## Final Amendment Report

Veld PV South Solar Energy Facility and  
associated infrastructure near Aggeneys in  
the Northern Cape  
**Veld PV South (Pty) Ltd**

Submission date: 2021/08/31

**Figure 3: Proposed amended site layout for Veld PV South (inclusive of the BESS and substation).**

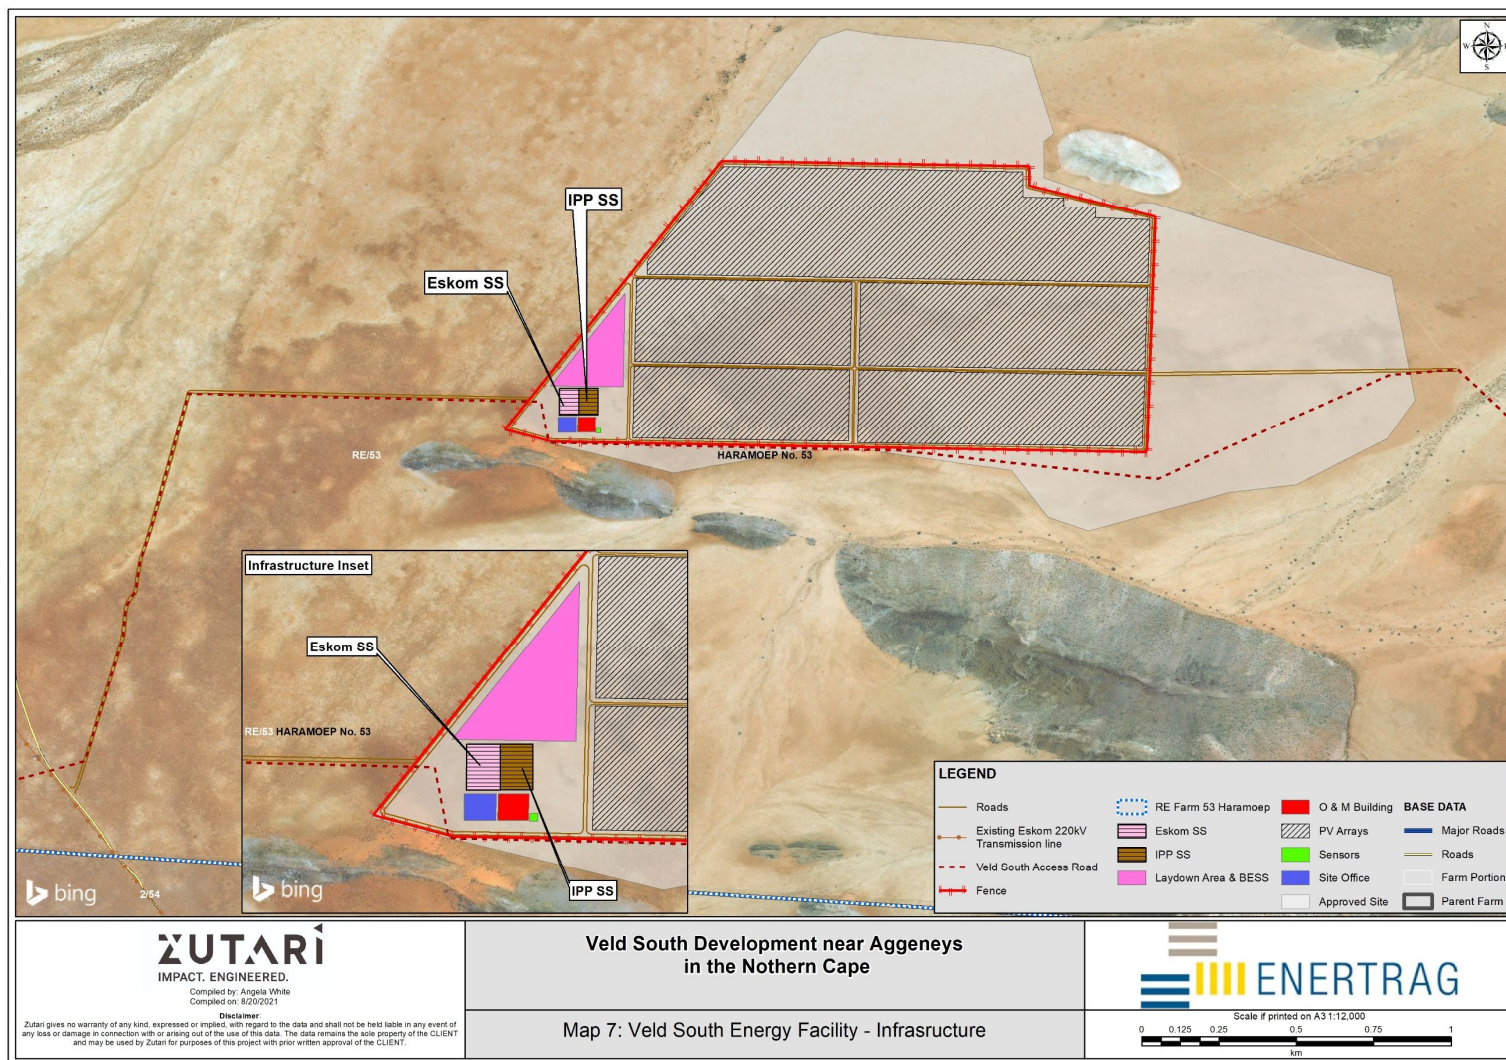
2. The approved final site layout plan (Condition 13), submitted as part of the BAR dated 25 February 2020, is being updated to reflect an updated layout based on the latest optimised technological solution for the facility.
3. The changed the length of the powerline is a correction of a typing error in the EA of 2020 that was only noticed during this amendment process (It appears the lengths were confused between the Veld PV North and Veld PV South applications). The correct length of 27km was applied for and assessed during the Basic Assessment of 2020.
4. The applicant has a new address.

12. A final site layout plan submitted as part of the BAR dated 25 February 2020 is hereby approved.		A final site layout plan submitted as part of the <del>BAR dated 25 February 2020</del> Amendment report dated (TBC) August 2021 is hereby approved.	
		Motivation/Reason: <i>The applicant wishes to update the site layout.</i>

5. Management of activity			
	12. A final site layout plan submitted as part of the Amendment report dated 31 August 2021 is hereby approved.		
	Motivation/Reason: <i>The applicant wishes to update the site layout.</i>

**Figure 4: Proposed site layout for Veld South Grid connection infrastructure**

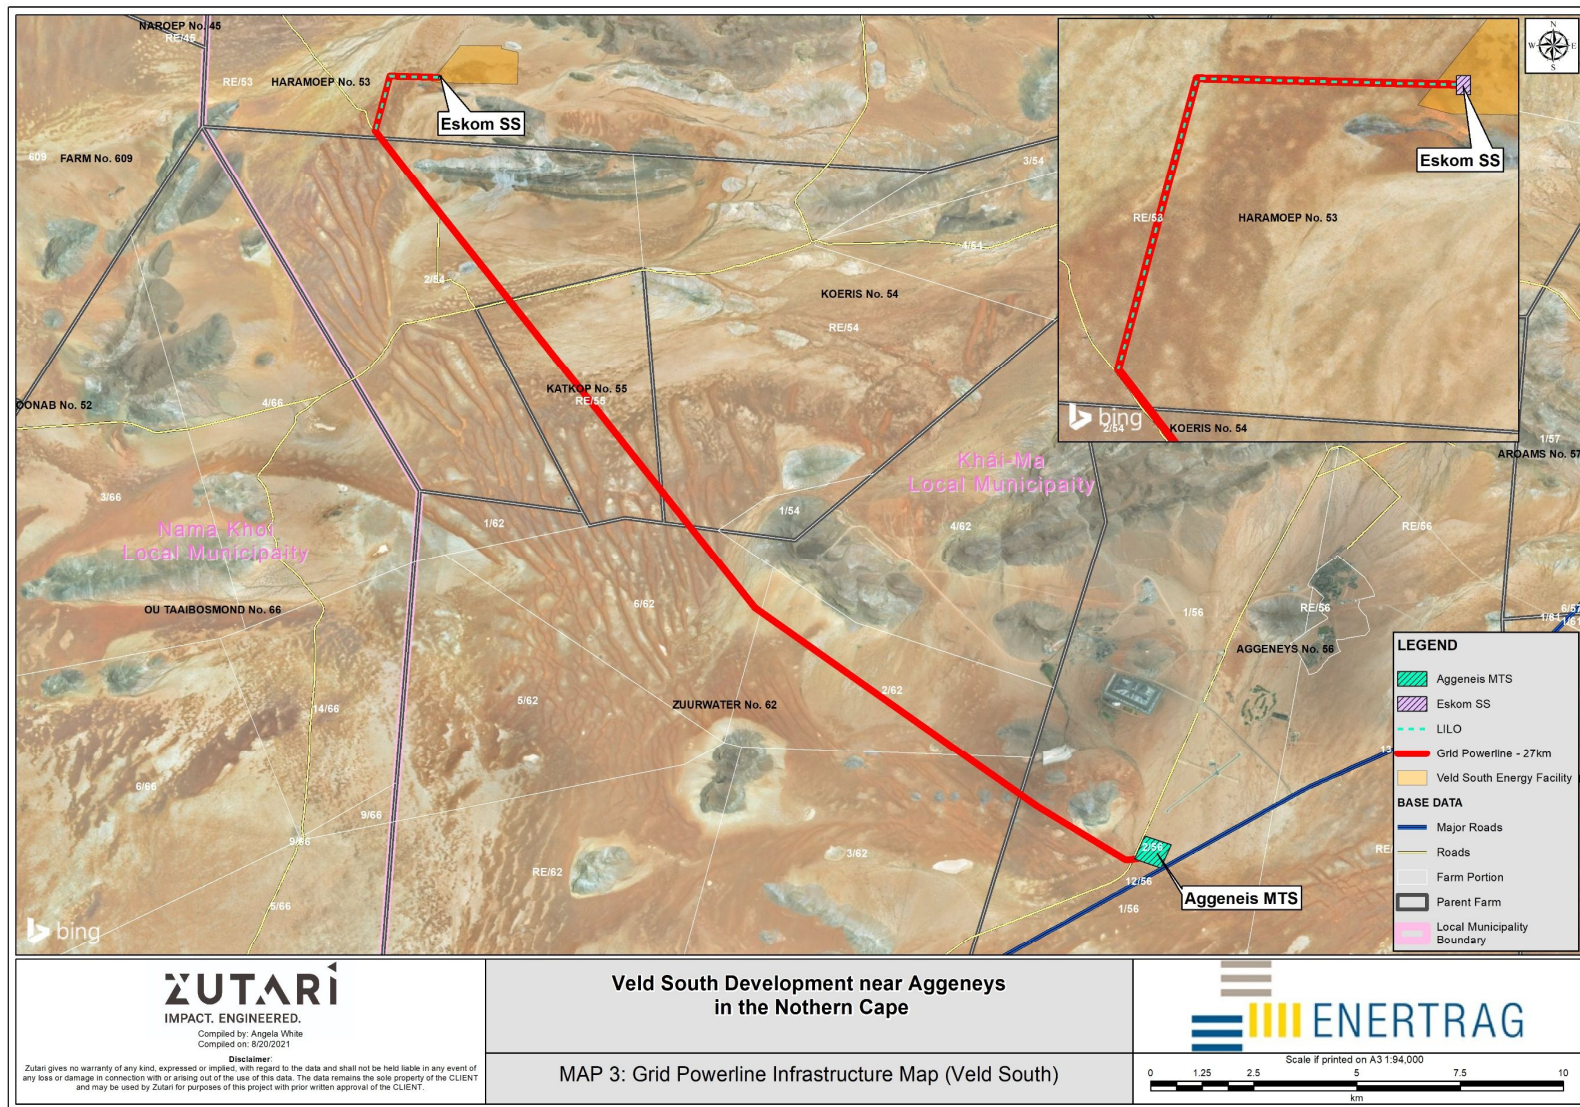
The applicant wishes to separate the powerline and Eskom portion of the on-site substation from the authorised EA, this will result in having two separate EAs for the Veld PV South Solar Energy Facility and Veld PV South Grid connection.

Page 11 of the EA- Management of activity			
12. A final site layout plan submitted as part of the BAR dated 25 February 2020 is hereby approved.		A final <u>site grid connection</u> layout plan submitted as part of the <del>BAR dated 25 February 2020</del> <u>Amendment Report dated (TBC) August 2021</u> is hereby approved.

6. Management of activity		
	12. A final <del>site</del> <u>grid connection</u> layout plan submitted as part of the Amendment Report dated 31 August 2021 is hereby approved.	
	Motivation/Reason: <i>The layout plan is in relation to the Veld South PV Facility and therefore the Grid specific layout plan should be approved.</i>
